UNITED STATES PATENT AND TRADEMARK OFFICE

APPLICATION NO.	FILING DATE	FIRST NAMED INVENTOR	ATTORNEY DOCKET NO.	CONFIRMATION NO.
10/730,852	12/09/2003	Kiyonori Oyu	ELPIDA 03USFP943	5218
27667	7590	04/05/2006	EXAMINER	
HAYES, SOLOWAY P.C. 3450 E. SUNRISE DRIVE, SUITE 140 TUCSON, AZ 85718			NGUYEN, THINH T	
			ART UNIT	PAPER NUMBER
			2818

Office Action Summary

DETAILED OFFICE ACTION

Fig. 2 PRIOR ART

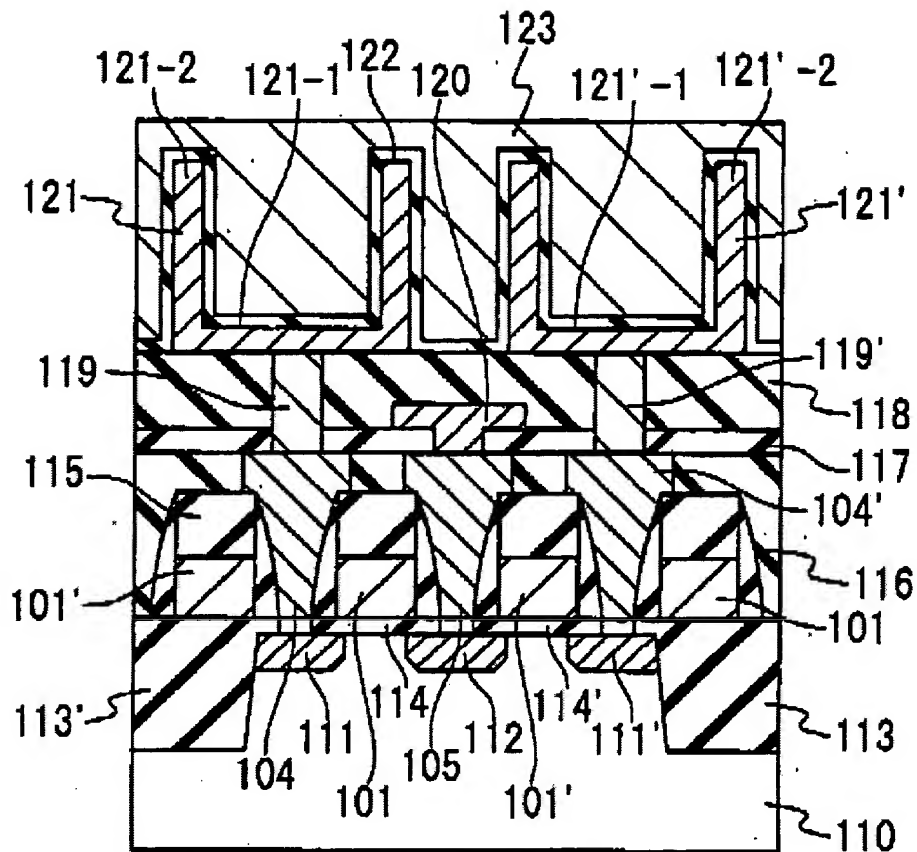
9. Claims 4-6 are rejected under 35 U.S.C. 103(a) as being unpatentable over Park et al. (U.S. Patent 6,396,096) in view of Applicant Admitted Prior Art or AAPA (Fig 2 of Applicant Application).

With regard to claim 4, Park discloses all the invention as set forth in the rejection of claim 2 except for going into detail about a first insulating film provided to cover the gate electrode; a first contact section formed to pass through the first insulating film to the first diffusion layer; a bit line formed on the insulating film; a second contact section formed to pass through the insulating film to the second diffusion layer, and a capacitive section formed on the first insulating film and connected to the first contact section. Applicant Admitted Prior Art, discloses a first insulating film provided to cover the gate electrode; formed to pass through the first insulating film to the first diffusion layer; a bit line formed on the insulating film; a second contact section formed to pass through the insulating film to the second diffusion layer, and a capacitive section formed on the first insulating film and connected to the first contact section.

It would have been obvious to one of ordinary skill in the art the time the invention was made to incorporated a first insulating film provided to cover the gate electrode; a first contact section formed to pass through the first insulating film to the first diffusion layer; a bit line formed on the insulating film; a second contact section formed to pass through the insulating film to the second diffusion layer, and a capacitive section formed on the first insulating film and connected to the first contact section of the AAPA into the Park et al. device since both Park and the AAPA are in the same endeavor of making DRAM.

With regard to claim 5-6, as set forth in the rejection of claim 4, the combined device disclosed by the AAPA and Park disclosed all the invention except for the side length of the first contact and the second contact. These features, however, are considered obvious since it has been held that when the general condition of a claim are disclosed in the prior art, discovering the optimum or workable ranges involves only routine skill in the art.

Fig. 5

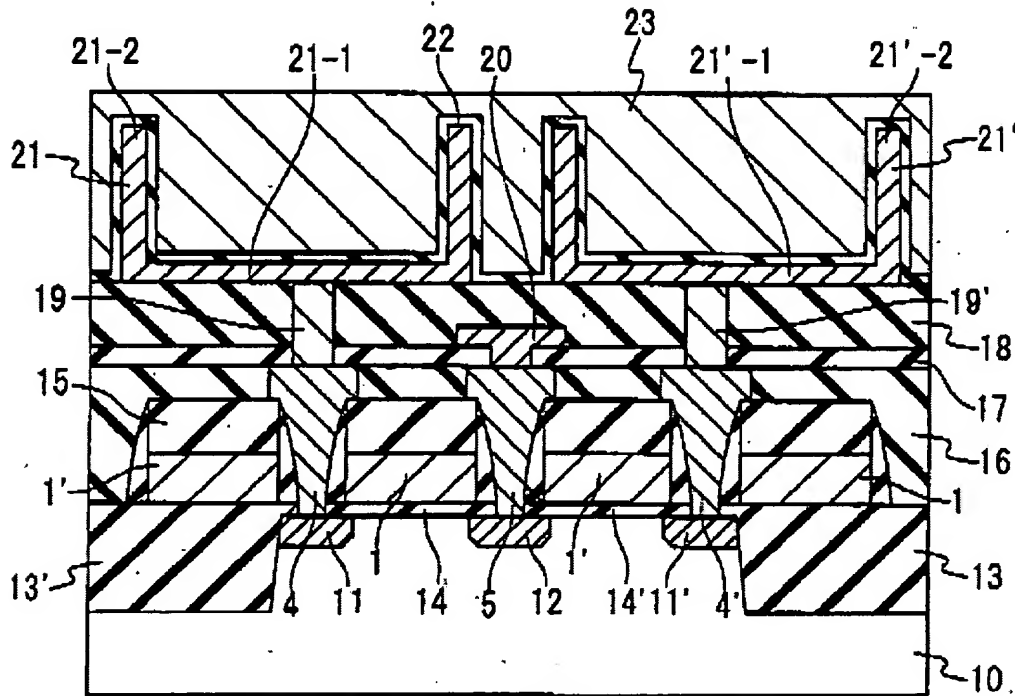
Park discloses (in the abstract, fig 5, column 4 lines 64-67) a semiconductor memory device (Park discloses a DRAM or Dynamic random access memory) comprising: a semiconductor substrate; and gate electrodes formed for a transistor on the semiconductor substrate through a gate insulating film, wherein a gate length of said gate electrode is longer than a half pitch (or minimum processing dimension F).

Park discloses (in the abstract, fig 5, column 4 lines 64-67, column 4 line 29) a semiconductor memory device, comprising: a first diffusion layer formed in a surface of said semiconductor substrate to function either as a source or a drain and a second diffusion layer formed in the surface of said semiconductor substrate to function either as a source or a drain, wherein the shortest distance between said first diffusion layer and said second diffusion layer is proportional to said gate length.
